AMENDMENT TO FACILITY OPERATING LICENSE

Amendment No. 6
License No. DPR-51

CHANGE NO. 6 TO THE TECHNICAL SPECIFICATIONS

SAFETY EVALUATION BY THE OFFICE OF NUCLEAR REACTOR REGULATION

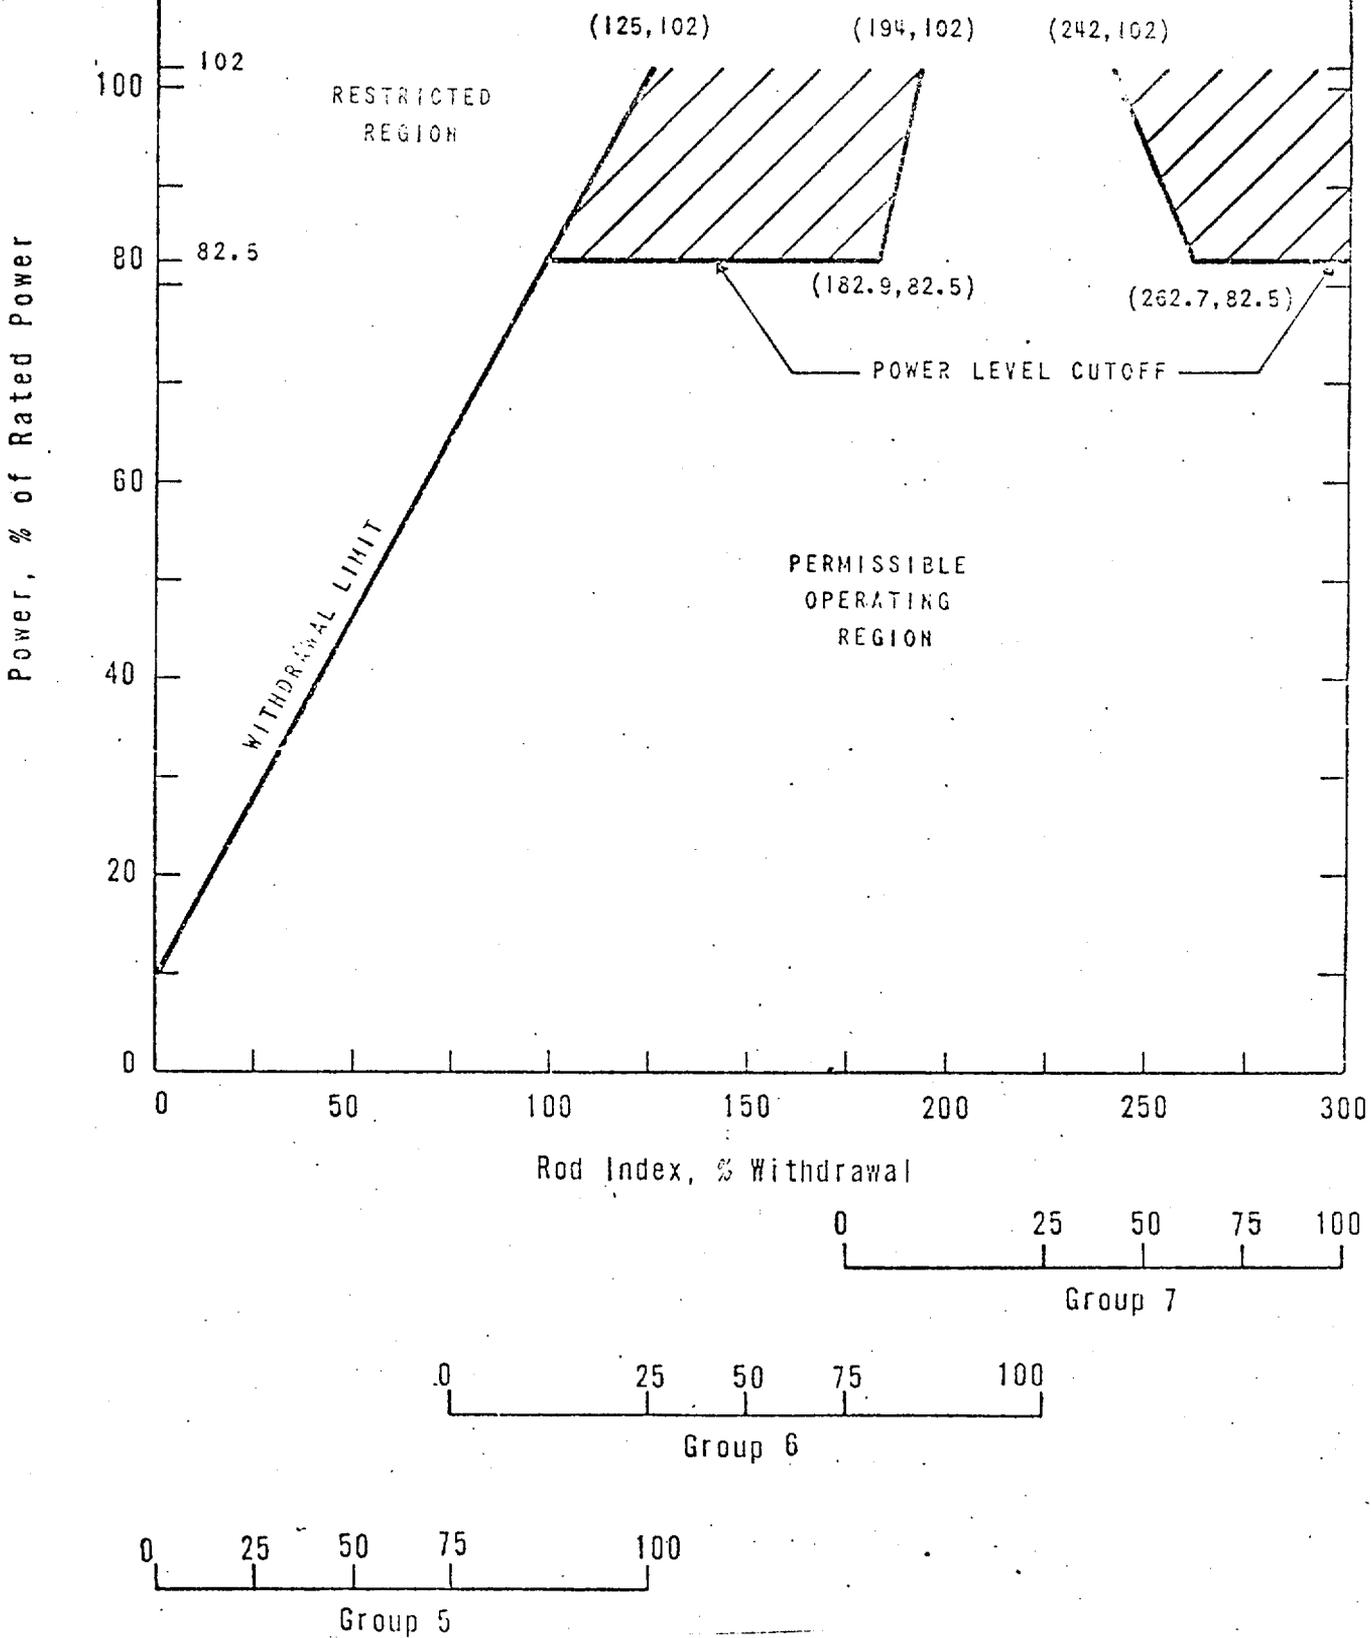
1. Rod index is the percentage sum of the withdrawal of the operating groups.
2. Restrictions on withdrawal (hashed areas) are modified after the control rod interchange (See Figure 3.5.2-18)

FIG. NO.
3.5.2-1B

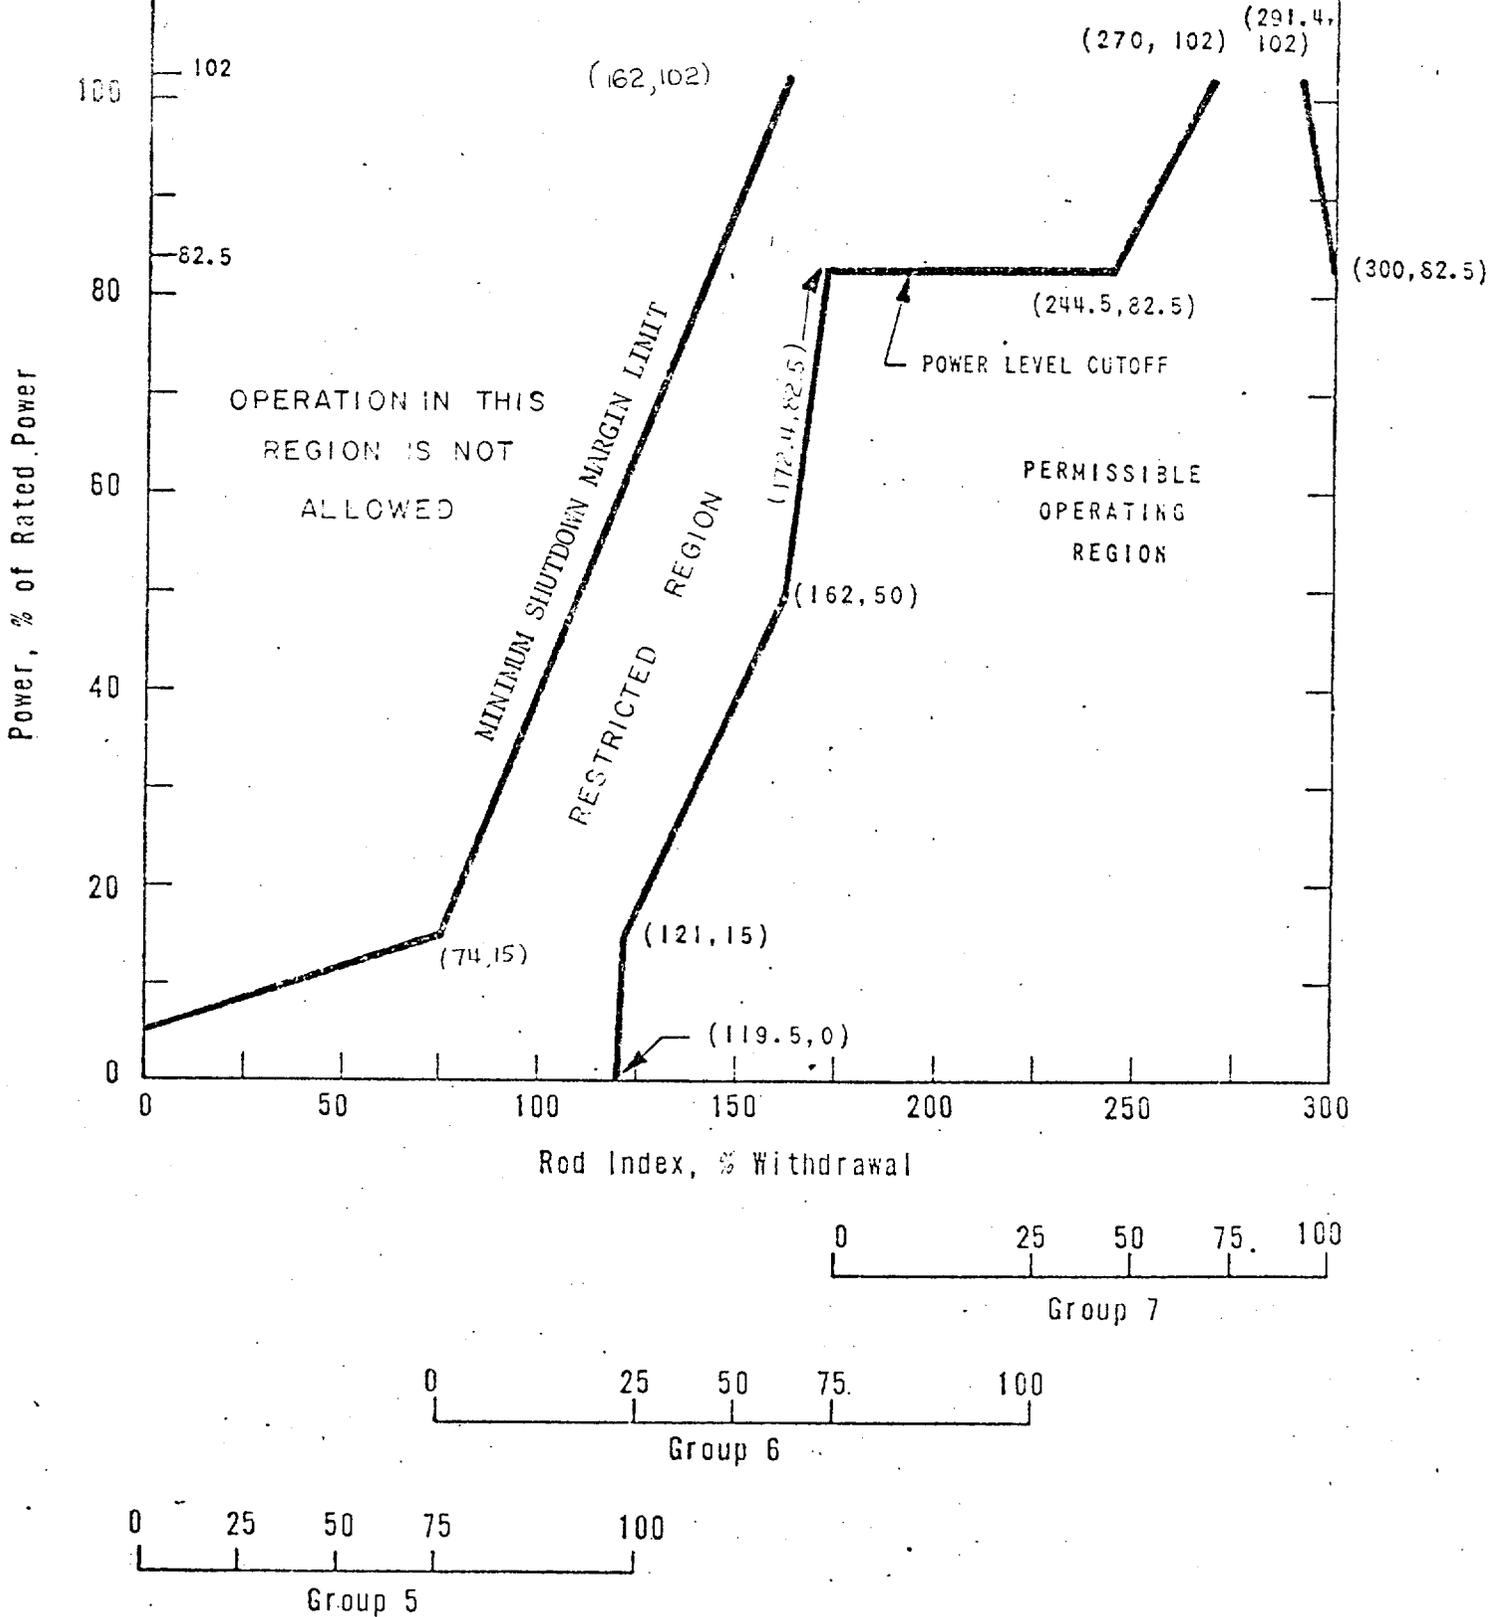
1. Rod index is the percentage sum of the withdrawal of the operating groups.
2. The additional restrictions on withdrawal (hatched areas) are in effect after the control rod interchange. The restrictions on withdrawal are further modified after 435 full power days of operation (See Figure 3.5.2-1C).

ARKANSAS POWER & LIGHT CO. ARKANSAS NUCLEAR ONE-UNIT 1	CONTROL ROD GROUP WITHDRAWAL LIMITS FOR 4 PUMP OPERATION	FIG. NO. 3.5.2-1C
---	---	----------------------

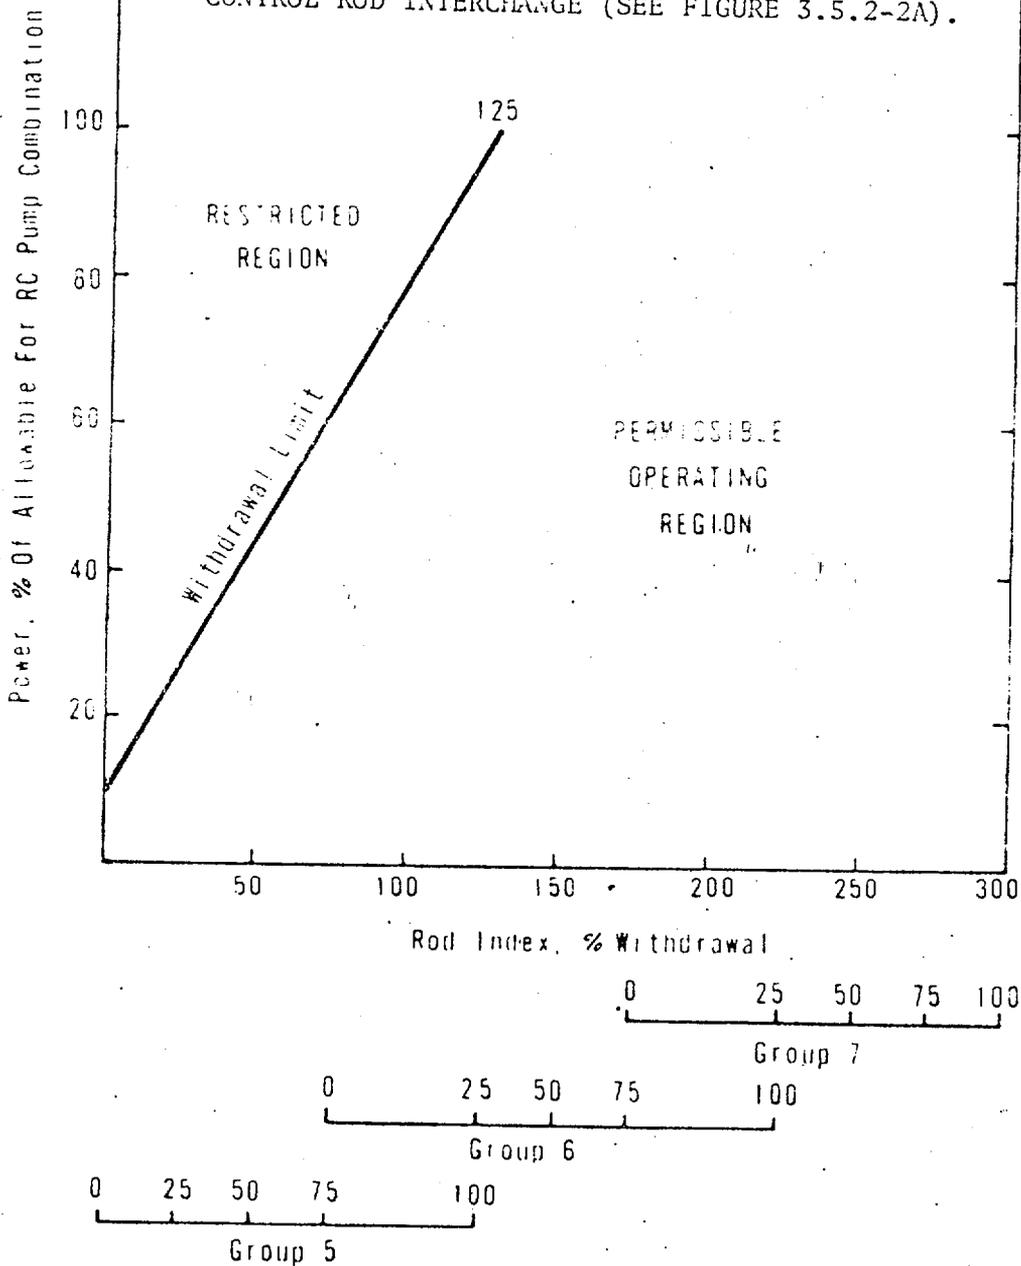
1. Rod index is the percentage sum of the withdrawal of the operating group.
2. The additional restrictions on withdrawal are in effect after 435 full power days of operation.

ARKANSAS POWER & LIGHT CO. ARKANSAS NUCLEAR ONE-UNIT 1	CONTROL ROD GROUP WITHDRAWAL LIMITS FOR 3 AND 2 PUMP OPERATION	FIG. NO. 3.5.2-2
---	---	---------------------

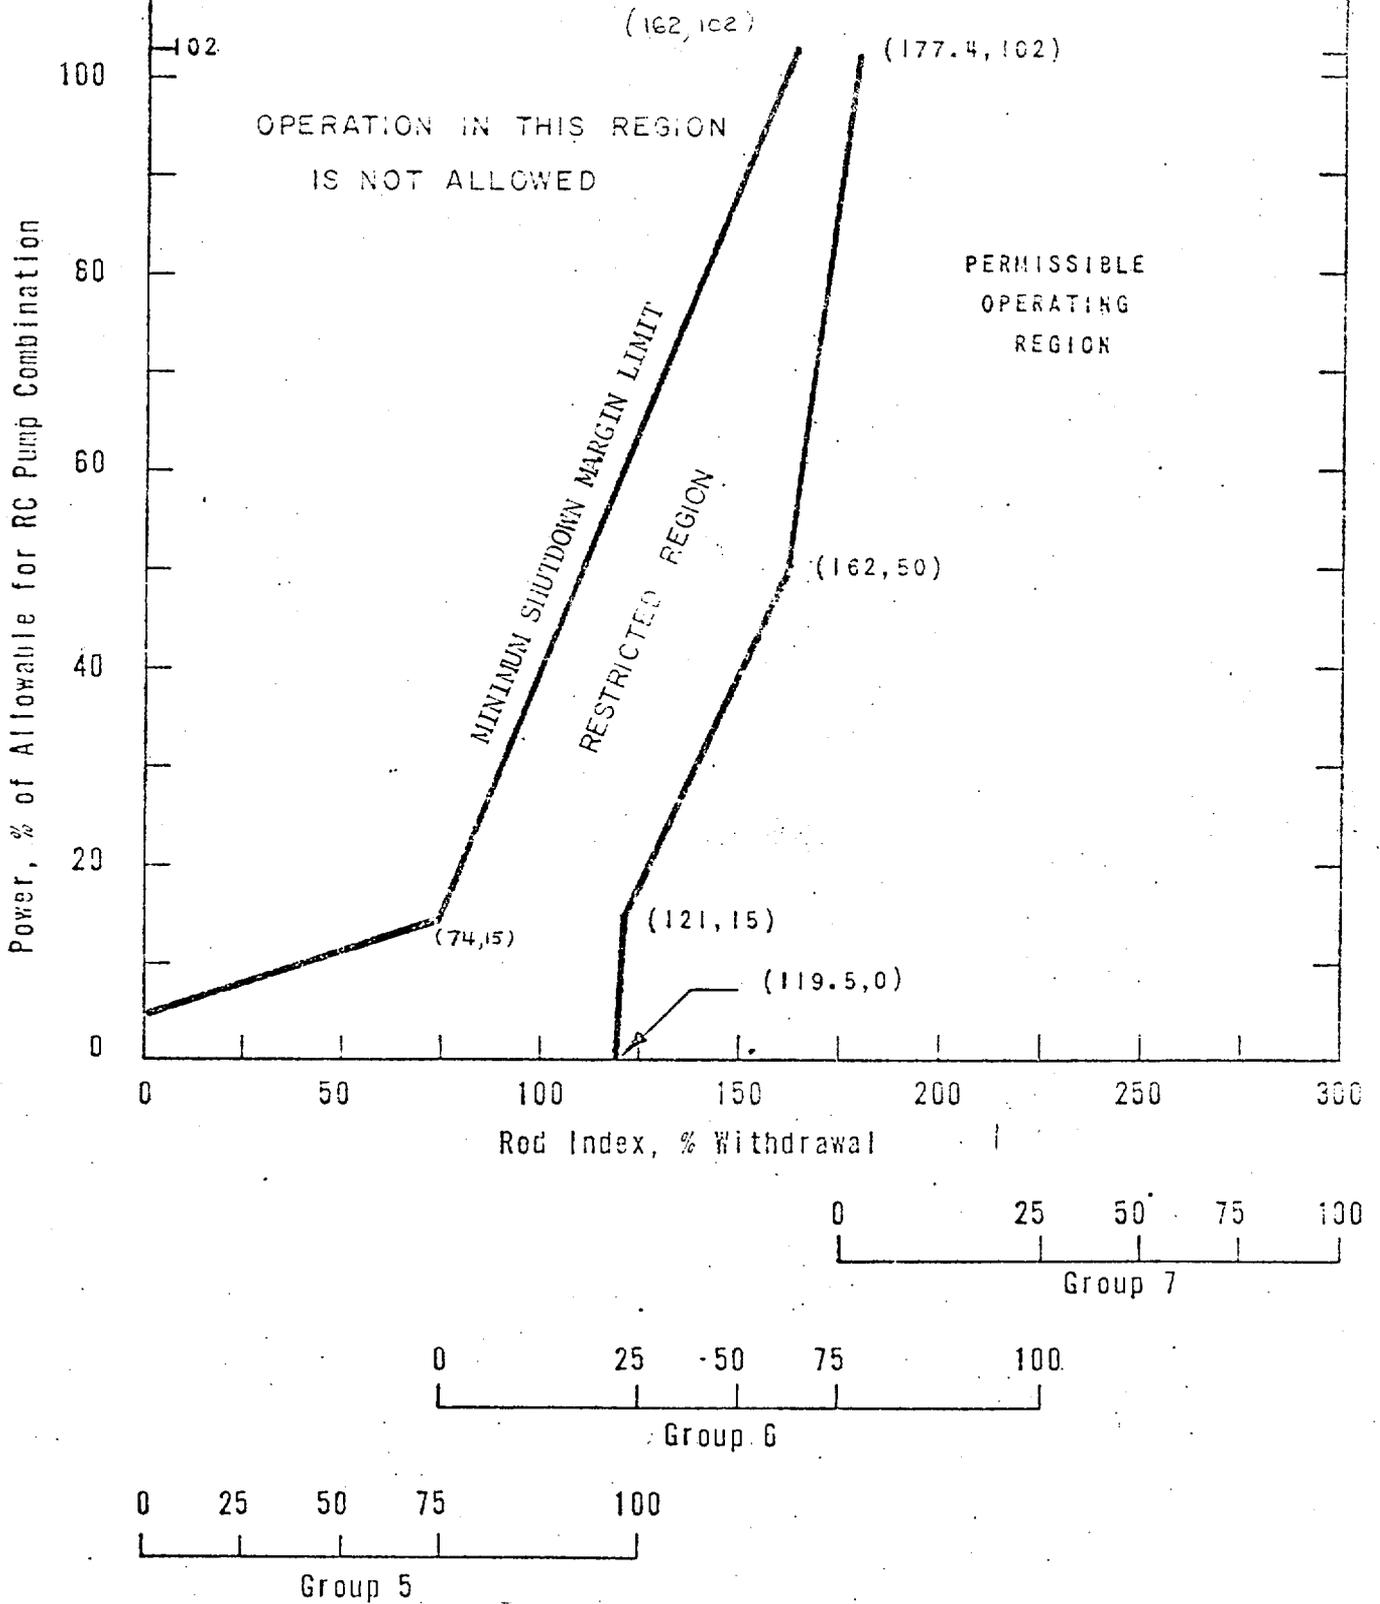
1. ROD INDEX IS THE PERCENTAGE SUM OF THE WITHDRAWAL OF THE OPERATING GROUPS.
2. ADDITIONAL RESTRICTIONS ARE REQUIRED FOLLOWING CONTROL ROD INTERCHANGE (SEE FIGURE 3.5.2-2A).
